**SANDOVAL COUNTY  
REGIONAL ANIMAL RESOURCE CENTER  
VISTA SANDIA COURT  
Bernalillo, New Mexico 87004**

**ADDENDUM NO. 02  
FY26 - SCPW - 07**

**December 5, 2025**

**B1 TRASH BIN ENCLOSURE**  
SCALE: 1"=5'-0"

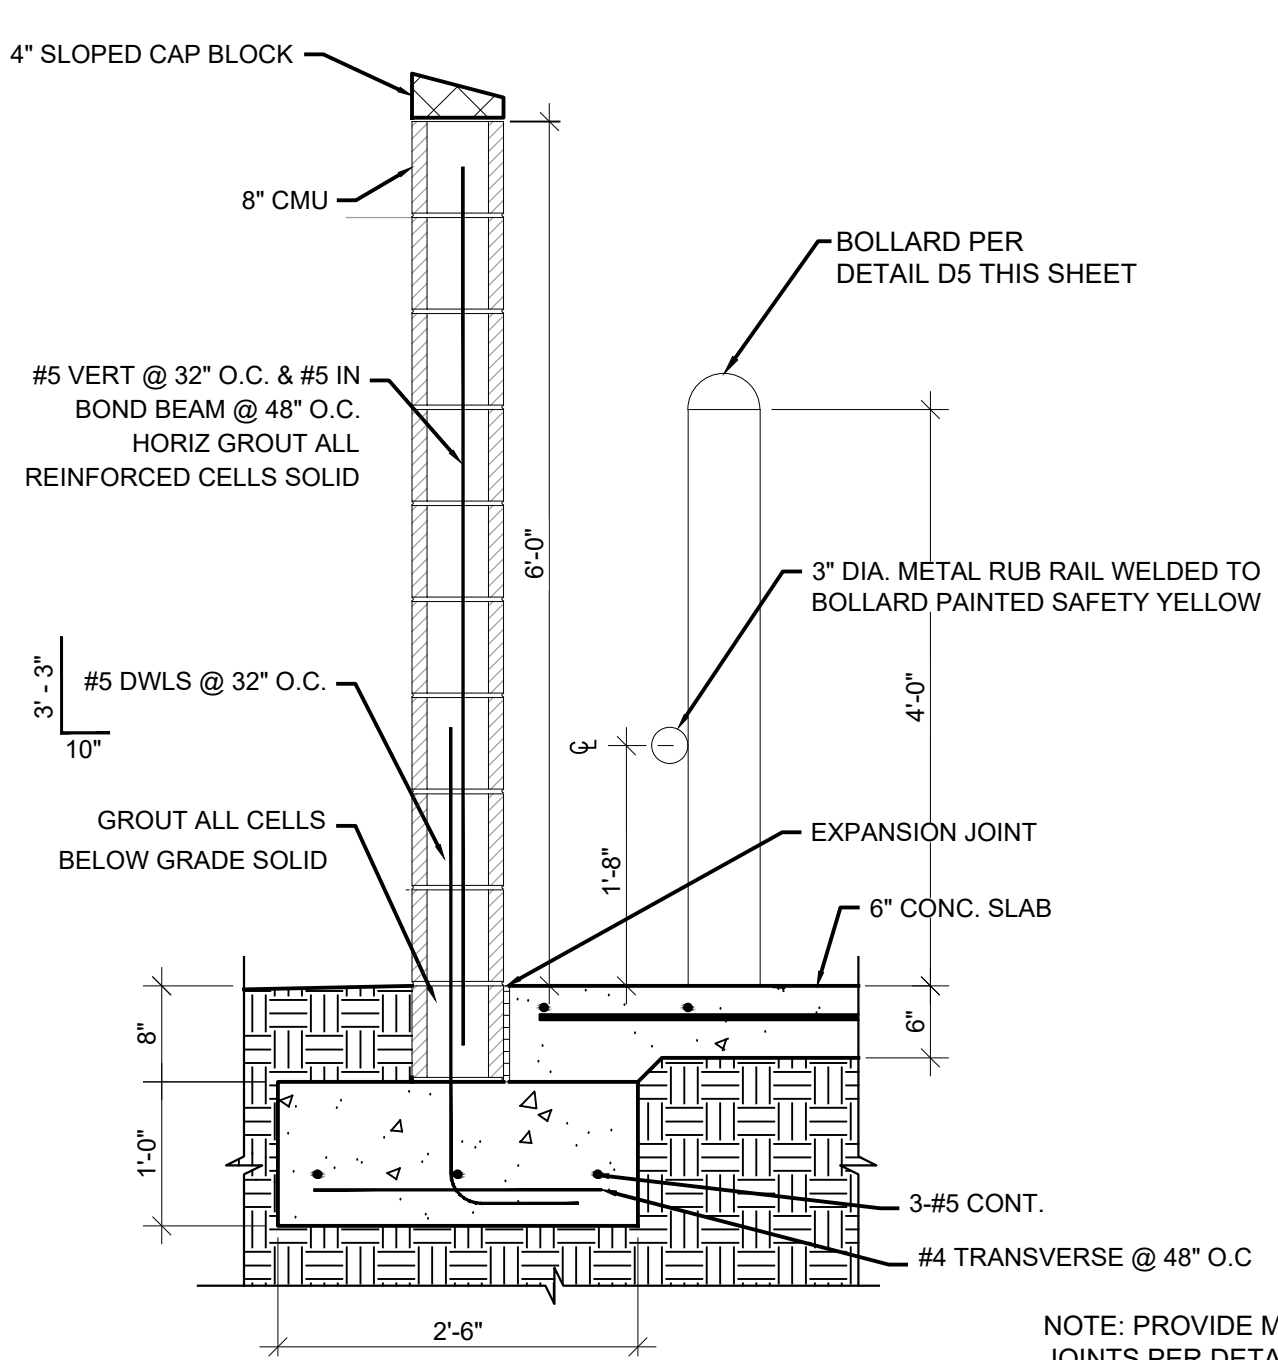
86. Sheet C501 detail B1 Trash Bin enclosure, please specify what the gate material is to be. Also, please provide layout/ location of metal pipe rub rail.

**Response; Gate materials and frame to match A4/AS401.  
Gate mesh: McNICHOLS® Wire Mesh; Square, Carbon Steel, Cold Rolled, Woven - Plain Weave, 3 x 3 Mesh (Square), 0.2283" x 0.2283" Opening (Square), 0.105" Thick (12 Gauge) Wire Diameter, 47% Open Area or equal.**

**B2 CMU WALL - TRASH BIN ENCLOSURE**  
SCALE: 1"=5'-0"

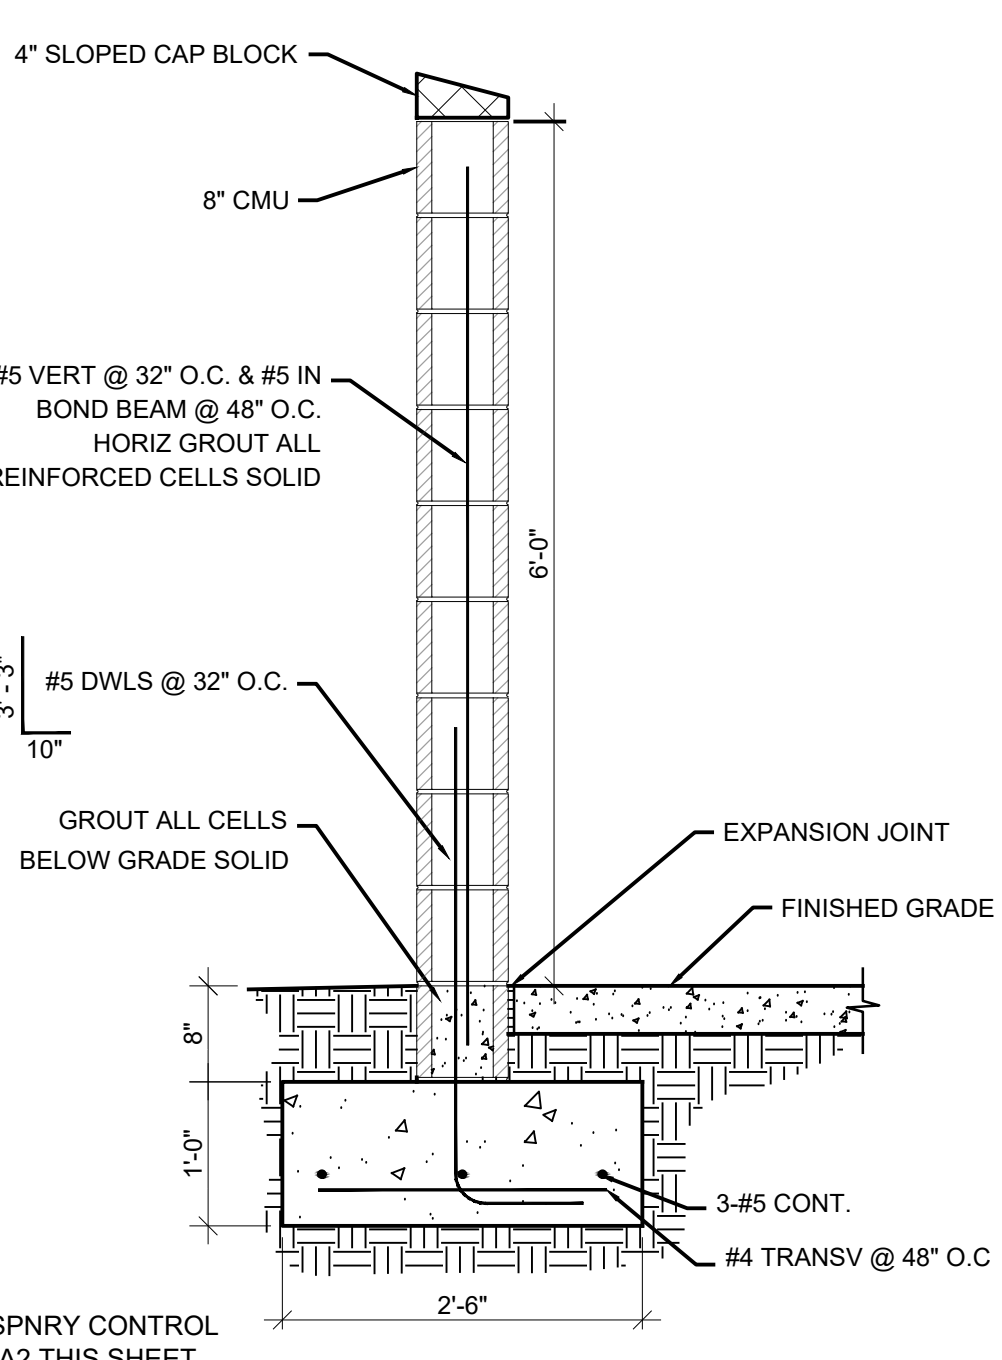
87. Sheet C-501 Detail B2, what is the finish to be of the Dumpster Masonry Wall Enclosure?  
**Response: exposed split face CMU with anti-graffiti coating.**

**Response: Flagpole to be located in sidewalk area near the SW corner of the Main building.**
132. Please clarify the height discrepancy for the trash enclosure CMU wall. Sheet C-501 detail B2 shows it at 6' however sheet AS401 detail A4 shows it at 12'. Please advise

**Response: refer to Addendum 01 Q54: provide per Sheet C-501.**
